Product Recall

Subject: RECALL 10V-486/10V-487 National Driver's Seat Pedestal

Technical Service Bulletin
NSC22955401
Seat Shock Replacement

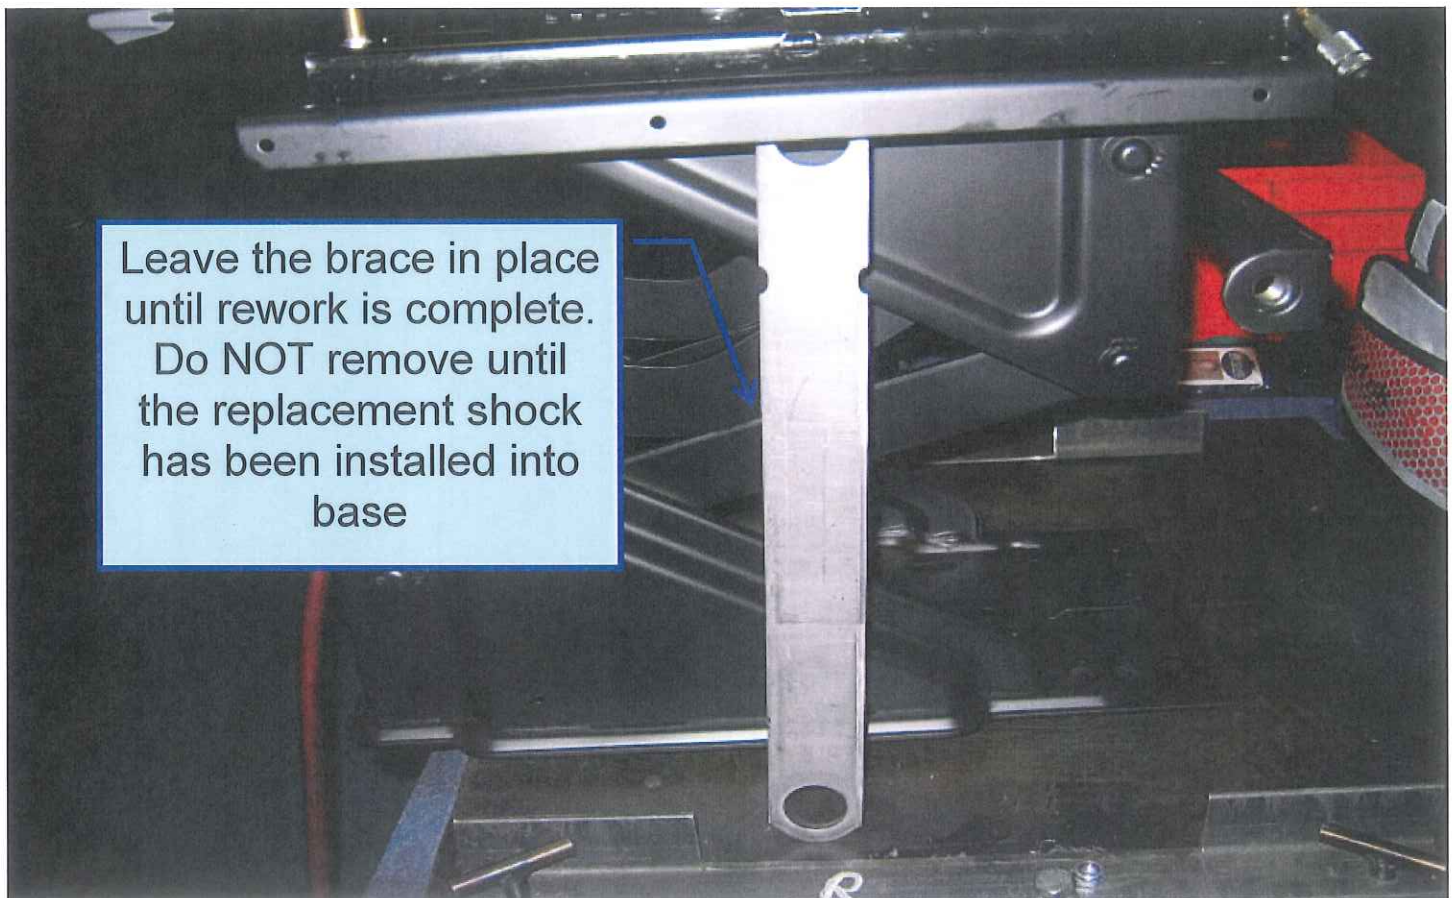
Shock part number: The part number and manufacture date is on the side of the shock. The date is a five digit code that identifies the day of manufacture and the year.

The manufacture date on this shock is the 43rd day (043) of 2010.

If you identify you have a shock within the defined date range National Seating will provide one of the following remedies;

- 1) If the shock(s) or seat bases were purchased as a replacement part in your inventory for future sale National Seating will issue credit for or provide replacement shocks or seat bases at no charge and pay returned freight to us.
- 2) If the shock is within a seat National Seating will pay .13 hrs labor to inspect the seat to determine if the shock falls within the suspect date range, and if so will pay an additional .8 hrs labor to replace the shock within the seat.

Step 2

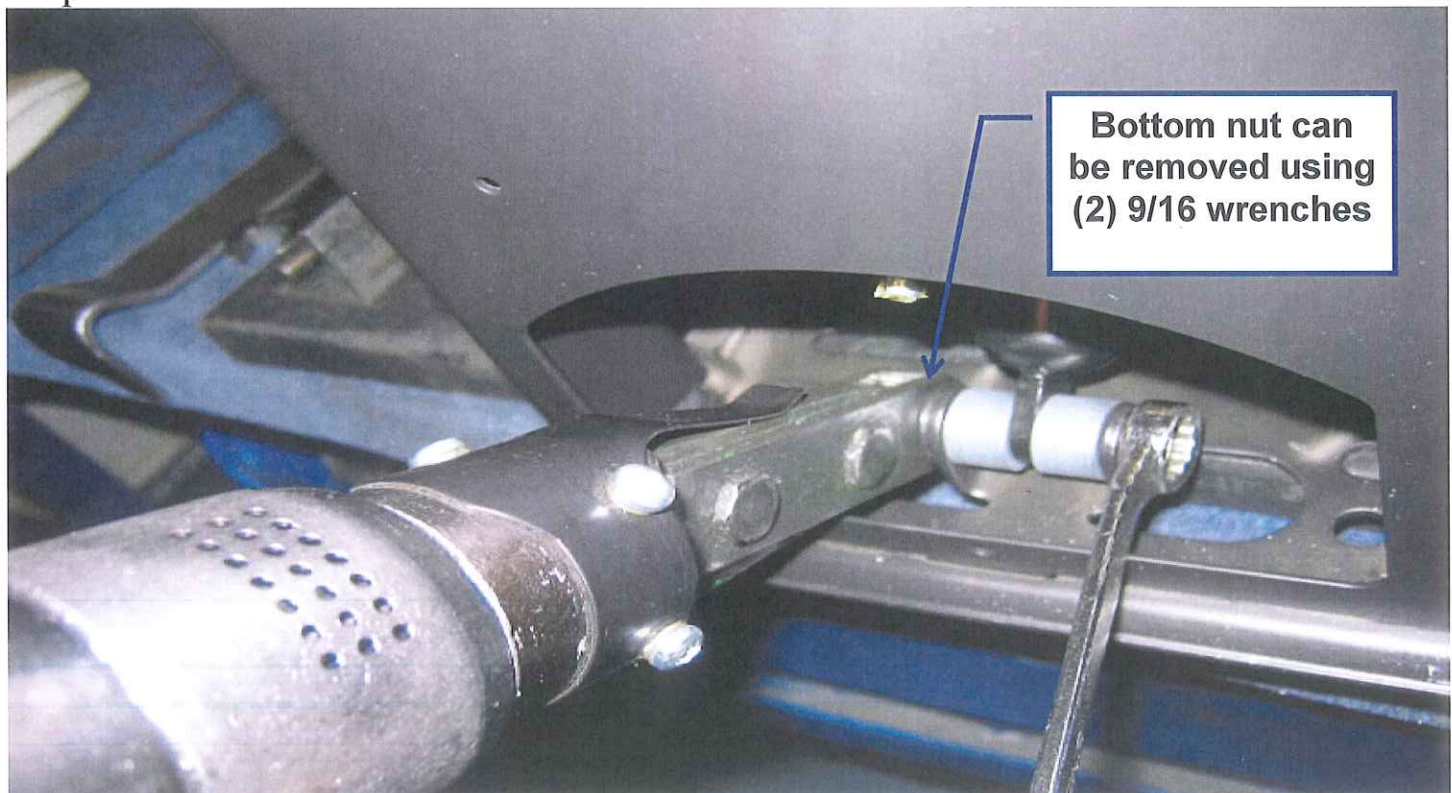
Once the seat base is blocked up at full extension, remove the cable from the release lever.

Step 3

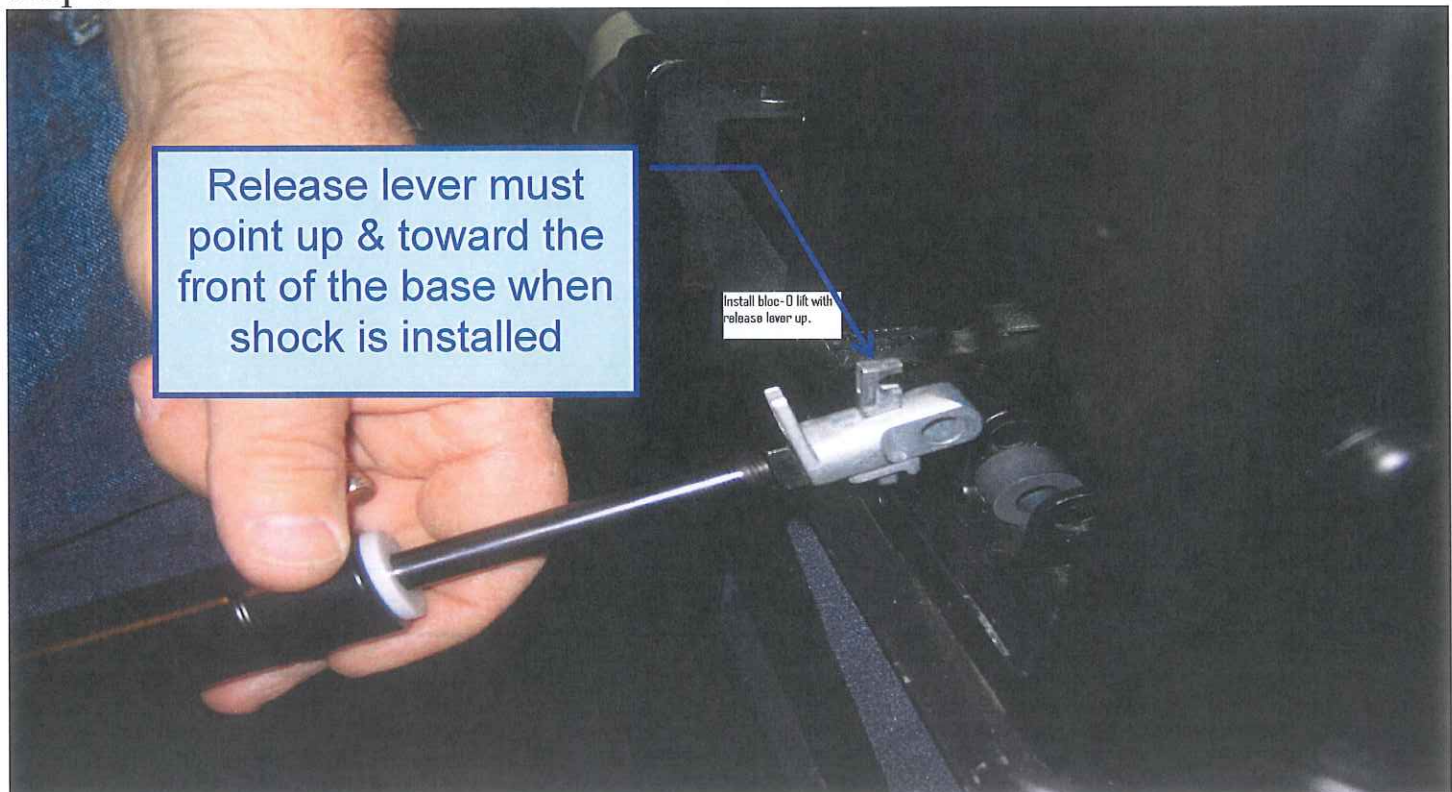
Remove the nut from the bottom mounting bolt, but leave the bolt in place.
